Commission of Architectural Review

1. COA-137121-2023	Final Review	Meeting Date: 11/28/2023
Applicant/Petitioner	Brian Spencer	
Project Description	Replace an existing concrete curb and stairs with brick.	
Project Location		
Address: 313 North 32 nd Street		
Historic District: Chimborazo Park		
<p>High-Level Details:</p> <ul style="list-style-type: none"> A new duplex is being constructed at this address. The front steps of the new house do not line up with the extant concrete steps that are built into the east side of the concrete curb of the sidewalk. The owner of the new property plans to replace the concrete retaining wall with a small brick wall and brick steps to match the brick steps at 311 North 32nd Street. 		
Staff Recommendation	Partial Approval	
Staff Contact	Annie Delaroderie, anne.delaroderi@rva.gov , 804-646-6335	
Previous Reviews	<p>This project was presented to the Commission at the October 2023 Meeting. A Commissioner made a motion to defer the project. The commissioner suggested the owner should adjust the size and length of the porch steps instead of altering the historic concrete steps. All members of the Commission agreed to defer the project.</p> <p>Plans fo

Figure 3. The staircase of the new house at 313 North 32nd Street does not line up with the historic concrete step and curb.

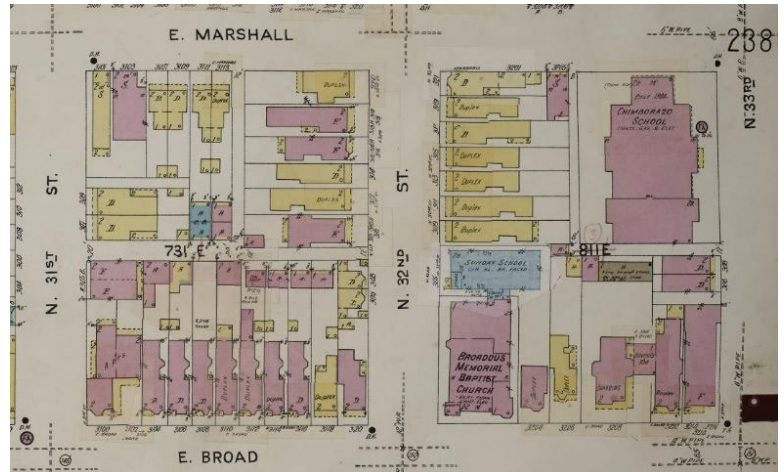
Conditions for Approval	<p>Staff recommendations</p> <ul style="list-style-type: none"> Staff recommends approval of the request to replace and repair the existing concrete stairs and retaining wall to align with the new construction's front stairs. Staff recommends that the concrete wall and steps be

<p>realigned and repaired/replaced in-kind with concrete. New wall and steps to match the existing dimensions.</p> <ul style="list-style-type: none"> • Staff recommends denial of the request to use brick for the new retaining wall and steps.
--	---
